APPLICATION NO.	FILING DATE	FIRST NAMED INVENTOR	ATTORNEY DOCKET NO.	CONFIRMATION NO.
09/172,553	10/14/1998	JAMES E. GREEN	2914.IUS	9441
7590	12/01/2004		EXAMINER	
JOSEPH A WALKOWSKI TRASK BRITT & ROSSA PO BOX 2550 SALT LAKE CITY, UT 84110			DIAZ, JOSE R	
			ART UNIT	PAPER NUMBER
			2815

Office Action Summary	Application No.	Applicant(s)
	09/172,553	GREEN ET AL.
	Examiner	Art Unit
	José R. Diaz	2815

DETAILED ACTION

F I G .4c

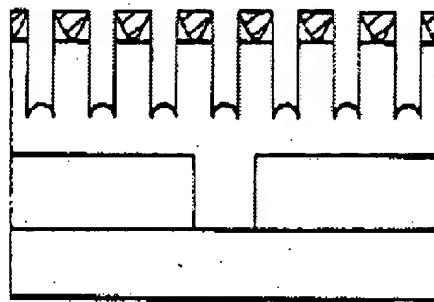
Regarding claims 31-32, 35 and 43, Jun et al. teaches an intermediate semiconductor capacitor structure (see figure 4c) comprising: a storage poly structure

(13) comprising a plurality of contiguous mesas (consider the fingers or columns that include mask 15 and HSG 14 in fig 4c) with recess formed therein (consider the space between the fingers or columns in fig. 4c); a contiguous hemispherical-grain polysilicon (14) over said storage poly structure (13) (see fig. 4c) and a mask (15) over said hemispherical-grain polysilicon layer (14), said recesses (consider the space between the fingers or columns) being exposed through said contiguous hemispherical-grain polysilicon (14) and said mask (15) (see figure 4c).

With regards to the terms "contiguous mesas" or "contiguous webs", please refer to figures 4c and 6c, below. Please note that figure 4c shows shallow recesses that do not disturb the continuity of the storage poly structure 13. Thus, figure 4c shows storage poly fingers connected throughout in an unbroken sequence.

F I G . 6c

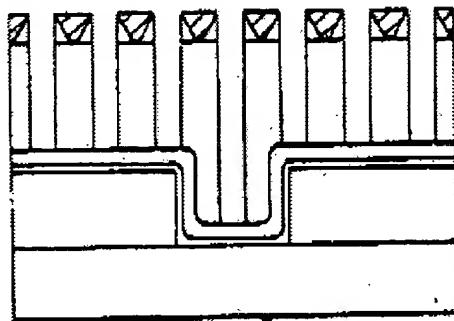
By the contrary, figure 6C shows deep recesses that disturb the continuity of the fingers. Thus, in this case figure 6c does not show contiguous fingers. Therefore, the terms "contiguous mesas" or "contiguous webs" in view of Jun et al. will be define according to

figure 4c, in which shallow recesses are provided without disturbing the continuity of the storage poly.

Fig. 22

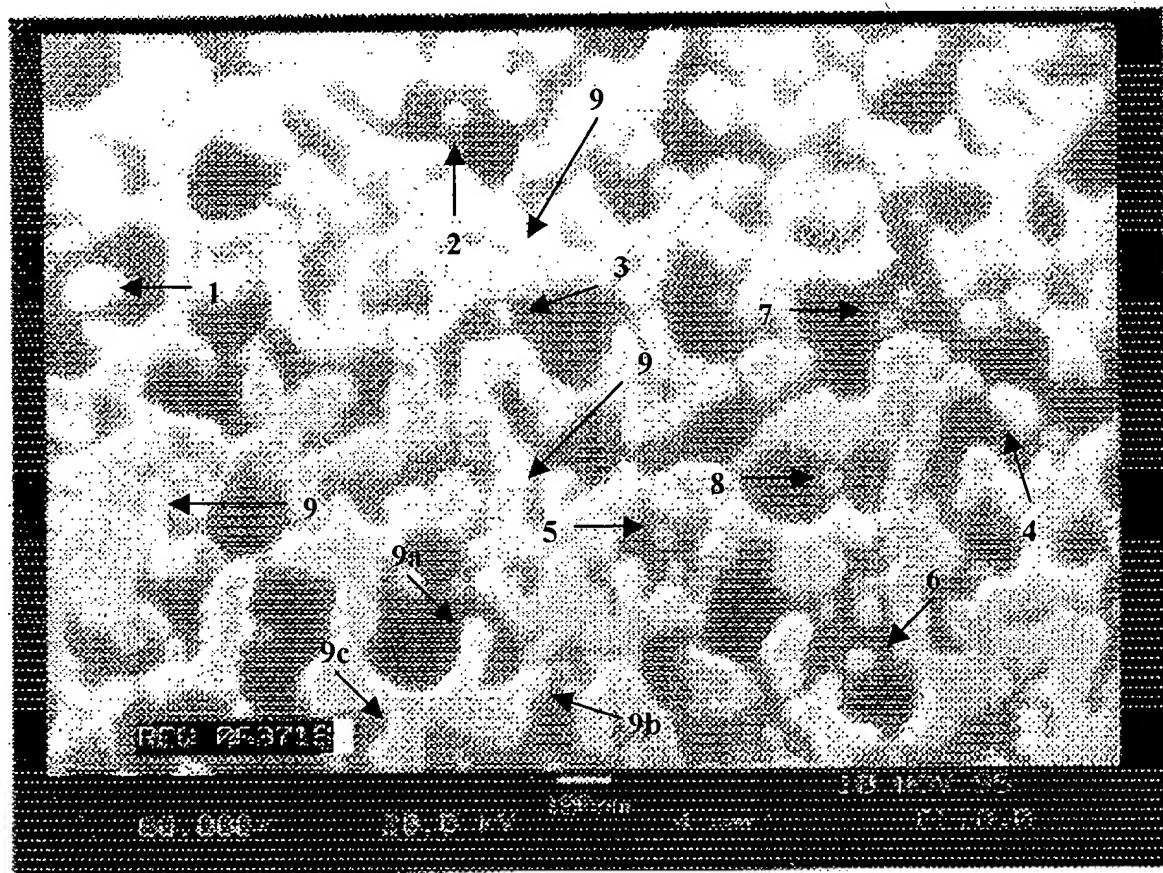
A mesa or web defined as a mere portion or region of a top surface. For example, the mesas or webs (fingers 9a-9c in figure 22, below) are "contiguous" because they share the same top surface (9).

Fig. 9

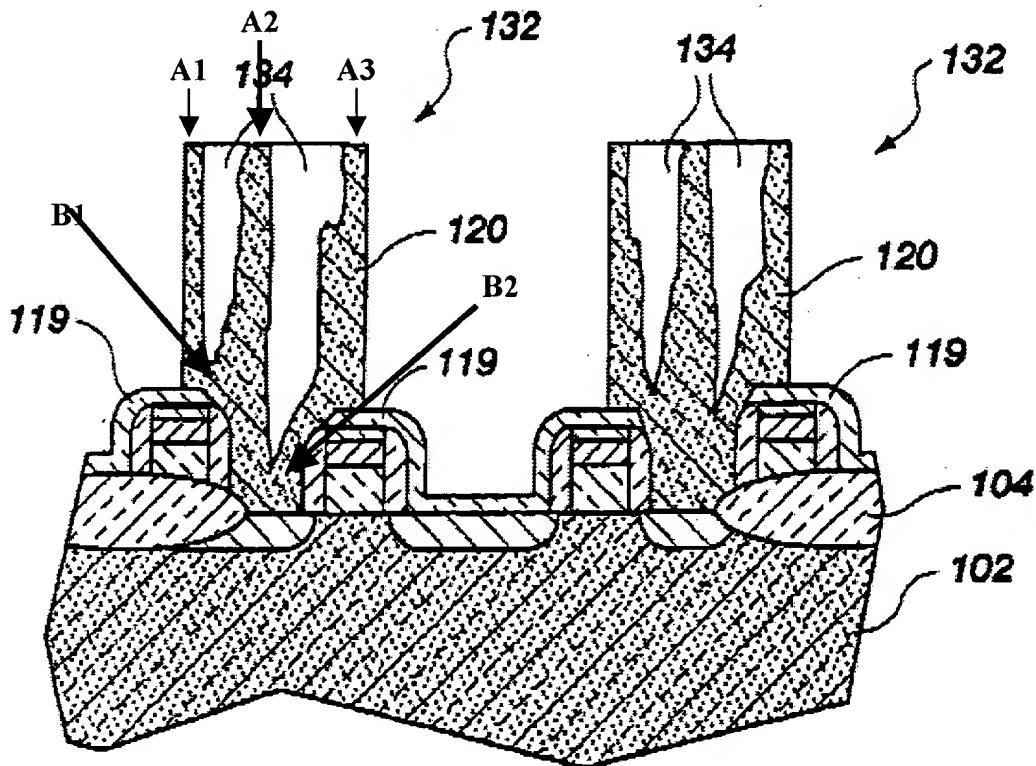
The mesas or webs are contiguous by sharing the same base. For example, top surfaces A1 and A2 share base (B1); and A2 and A3 share base (B2), which is adjacent to base (B1) (see fig 9, below).
